SUBJECT: ISSUANCE OF AMENDMENT NO. 26 TO FACILITY OPERATING LICENSE,
PALO VERDE NUCLEAR GENERATING STATION, UNIT NO. 3 (TAC NO. 79785)

PALO VERDE NUCLEAR GENERATING STATION, UNIT NO. 3

SAFETY EVALUATION BY THE OFFICE OF NUCLEAR REACTOR REGULATION

RELATED TO AMENDMENT NO. 26 TO FACILITY OPERATING LICENSE NO. NPF-74

FIGURE 3.1-1A

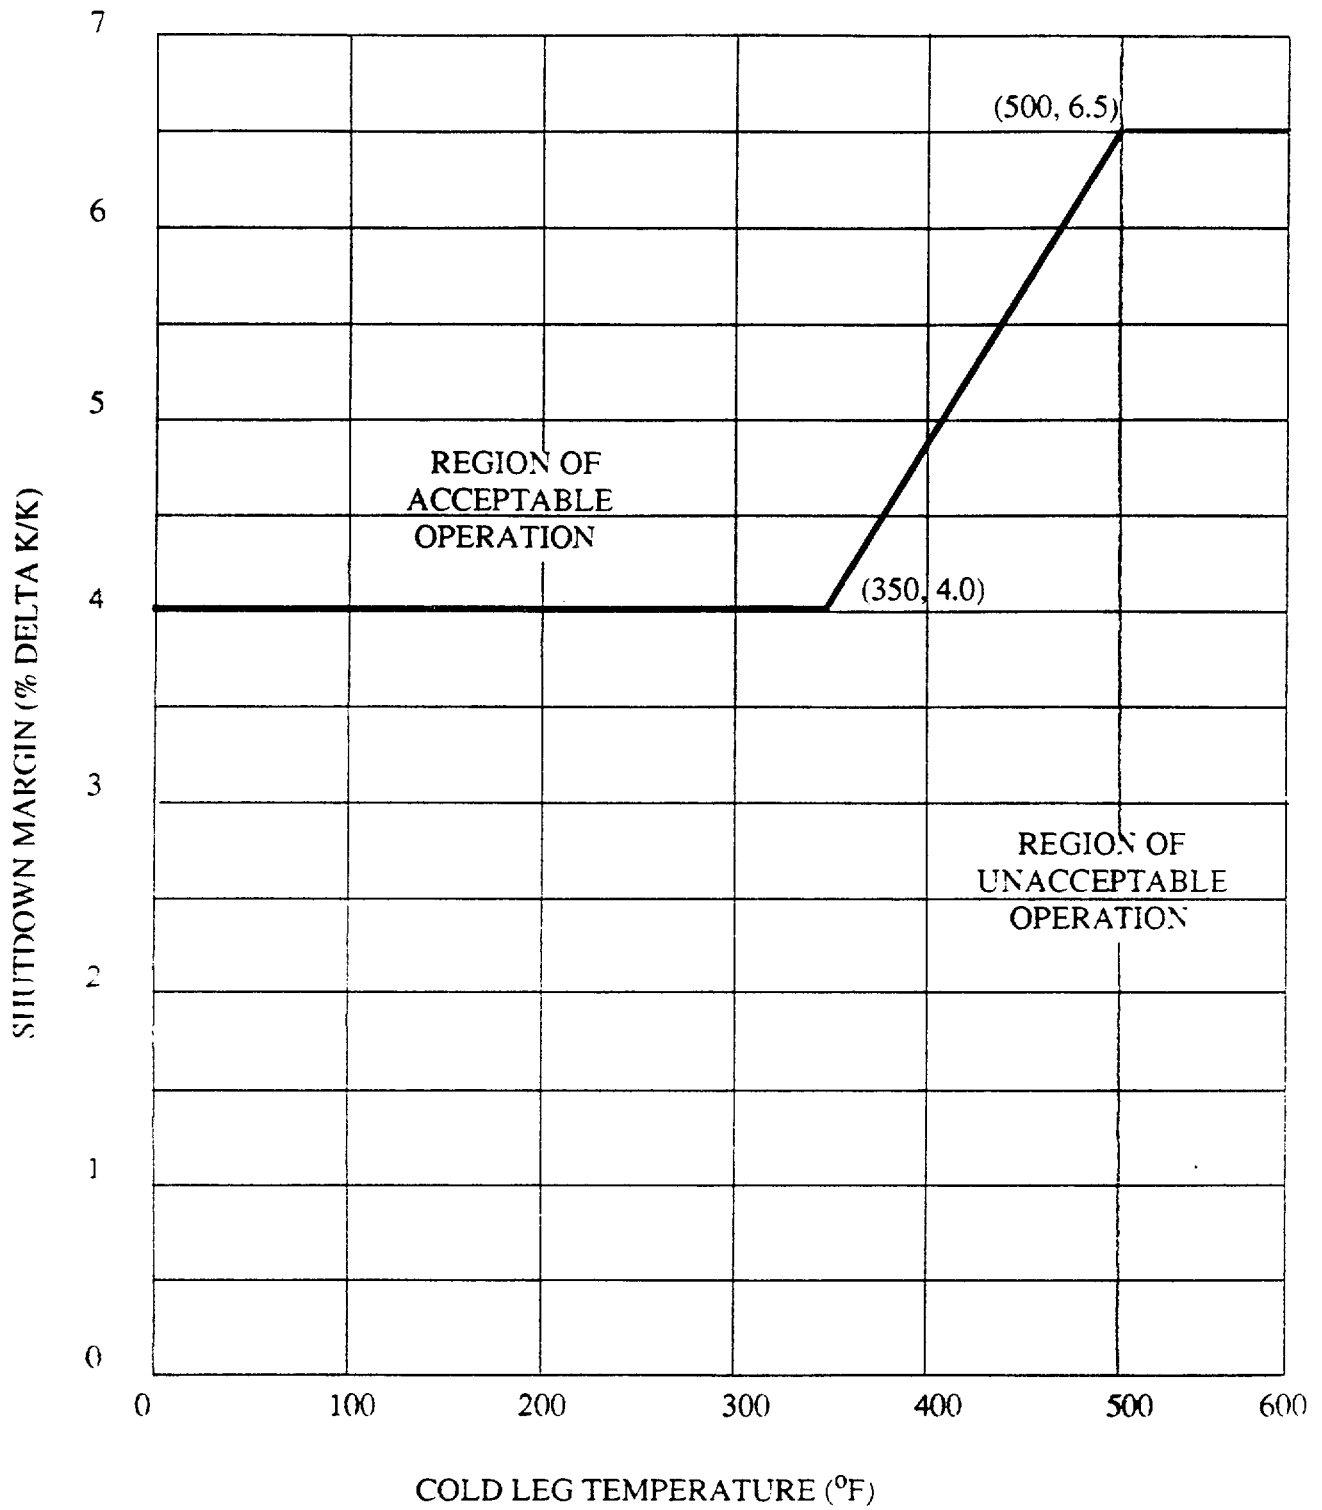
TS Figure 3.1-1A

The proposed change increases the required shutdown margin from 3.5 to 4.0 percent delta k/k for the RCS cold leg temperature range zero to 350°F when any full-length CEA is fully withdrawn.

The increased shutdown margin will ensure that the TS are consistent with the safety analyses performed for the Cycle 3 core and that the consequences of DBEs and anticipated operational occurrences are bounded by these analyses. The proposed change is therefore acceptable.

FIGURE 3.1-3
CEA INSERTION LIMITS VERSUS THERMAL POWER
(COLSS IN SERVICE)

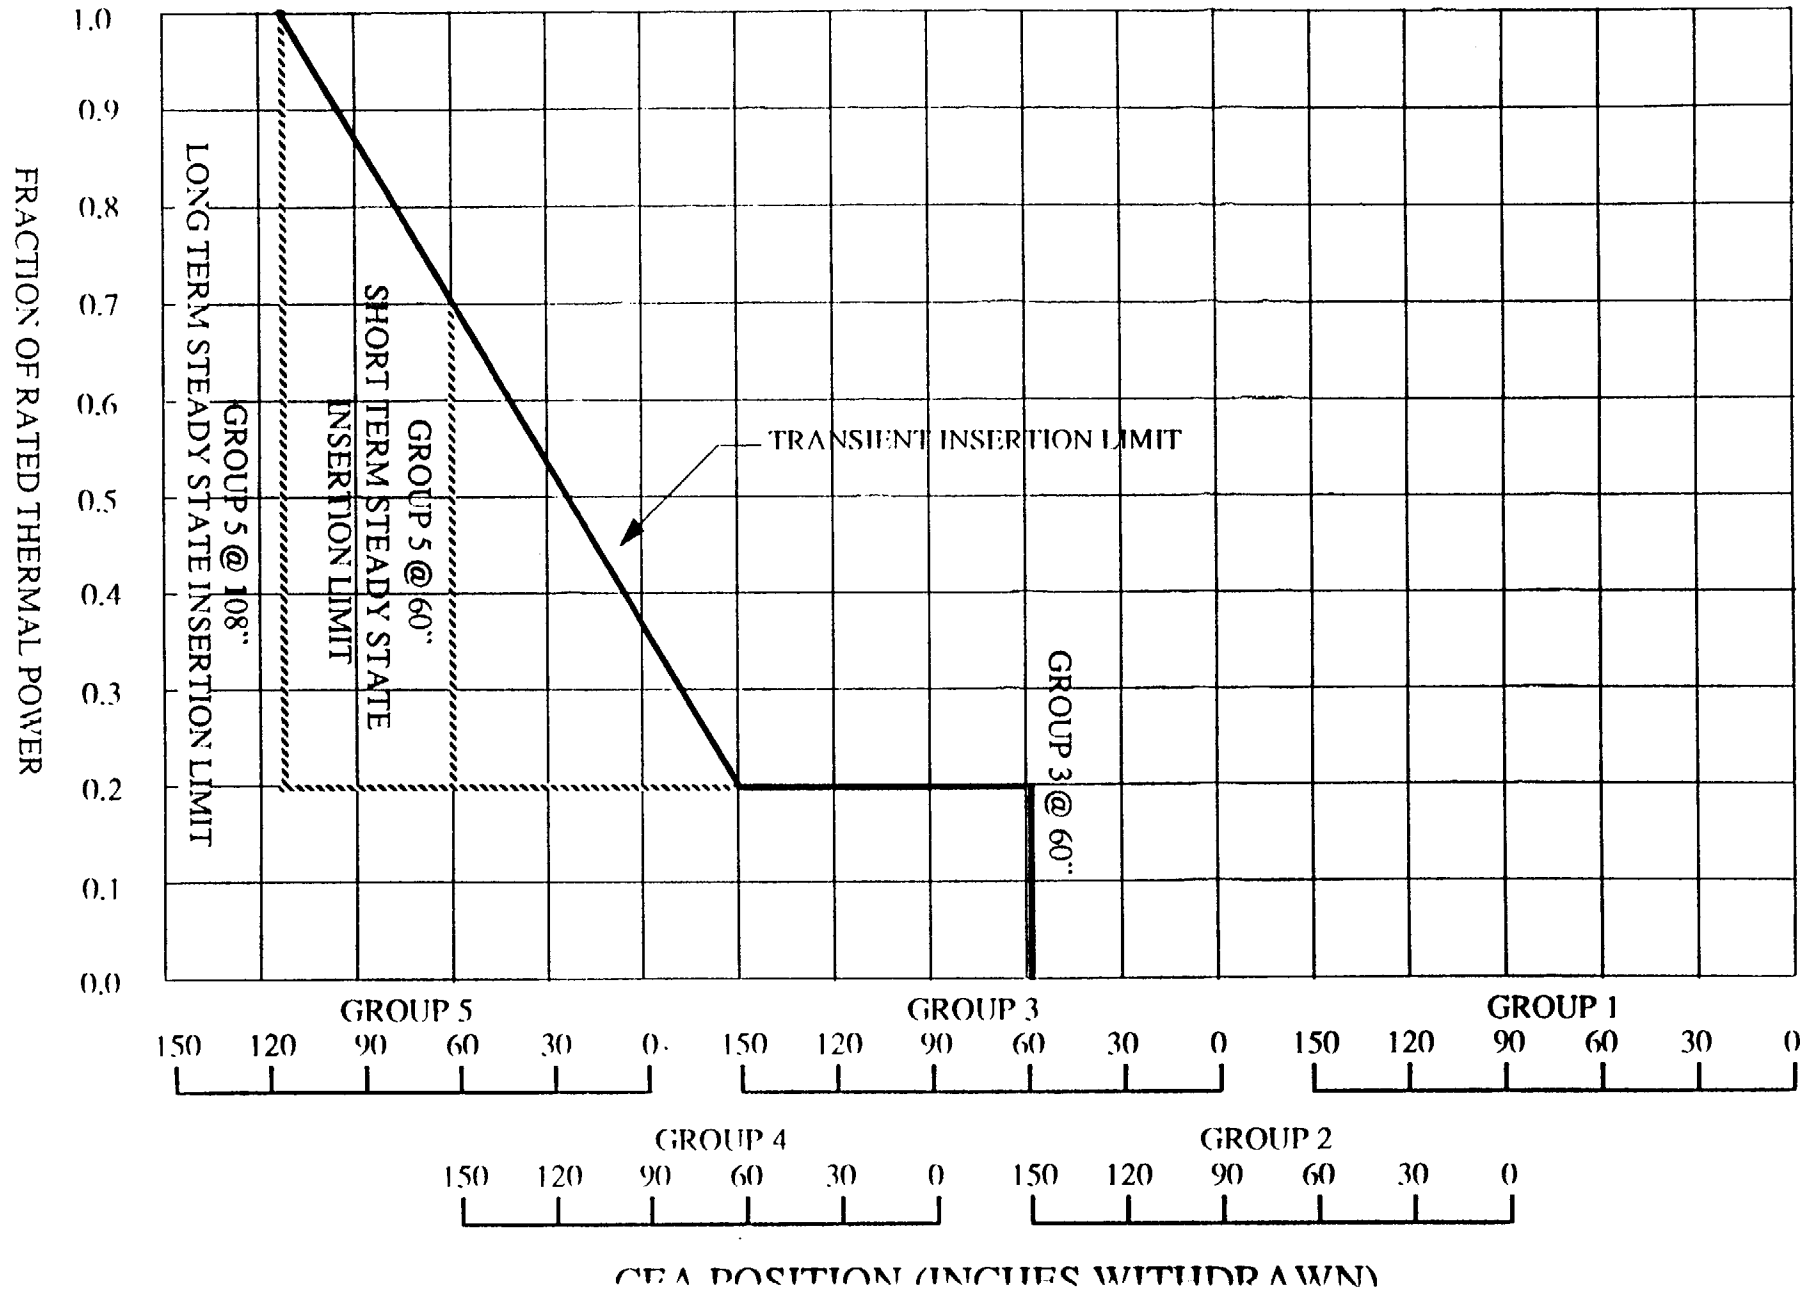
TS Figures 3.1-3 and 3.1-4

Figures 3.1-3 and 3.1-4 provide regulating group CEA insertion limits when the COLSS is in service and out of service, respectively. The proposed change to Figure 3.1-3 will prohibit insertion of regulating group 3 CEAs above 20 percent of rated thermal power. This is permitted under the existing TS. The proposed change to Figure 3.1-4 will permit slightly increased insertion of regulating group 3 CEAs between 15 percent and 20 percent of rated thermal power.

The proposed revisions are necessary to ensure consistency of the TS with the safety analyses performed for the Cycle 3 core. These analyses demonstrate that reactor operation in accordance with the revised insertion limits will ensure that the Specified Acceptable Fuel Design Limits (SAFDLs) will not be exceeded during the most limiting anticipated operational occurrence. The proposed changes are, therefore, acceptable.

FIGURE 3.2-2

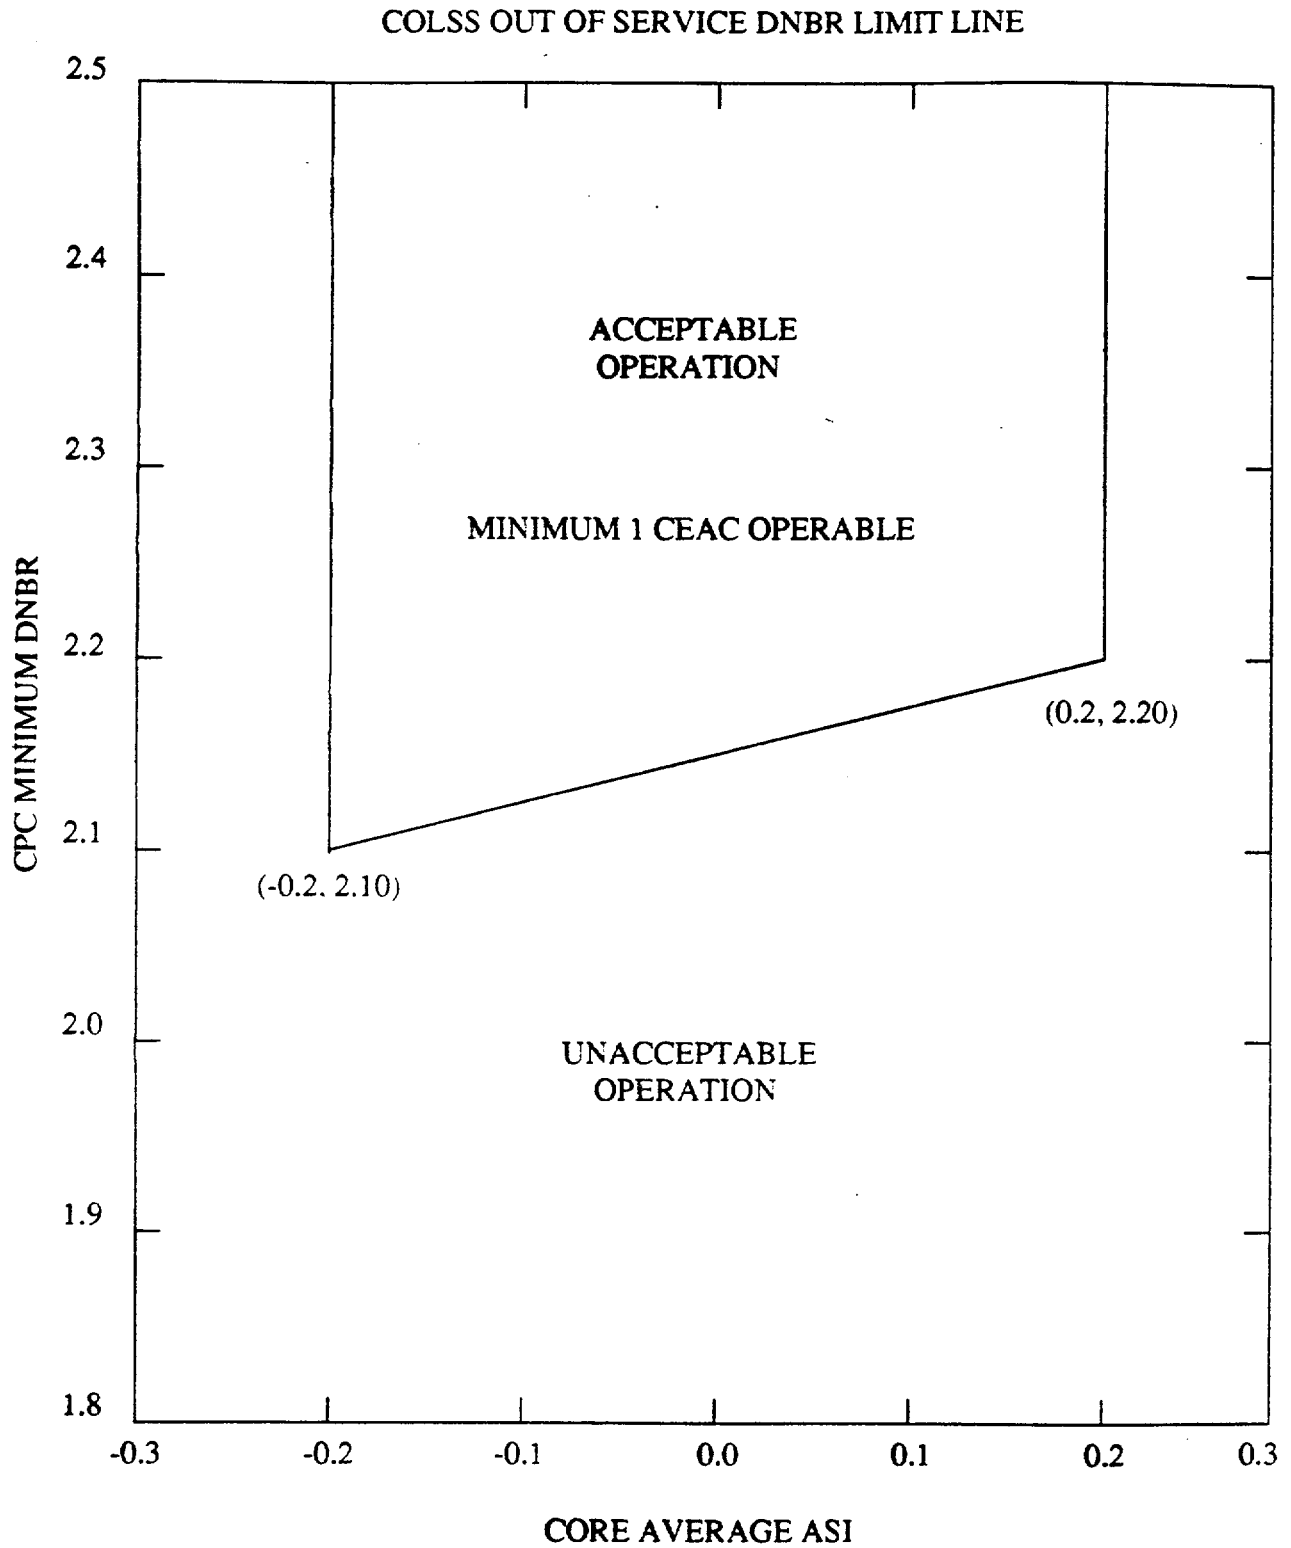
TS Figures 3.2-2 and 3.2-2A

Figure 3.2-2 provides DNBR margin limits when at least one Control Element Assembly Calculator (CEAC) is operable and the COLSS is out of service. Figure 3.2-2A provides the additional DNBR margin necessary when COLSS and both CEACs are out of service. Reactor operation within these limits ensures that the SAFDLs will not be violated during an anticipated operational occurrence.

The proposed changes are necessary to ensure consistency of the TS with the safety analyses performed for the Cycle 3 core and are, therefore, acceptable.
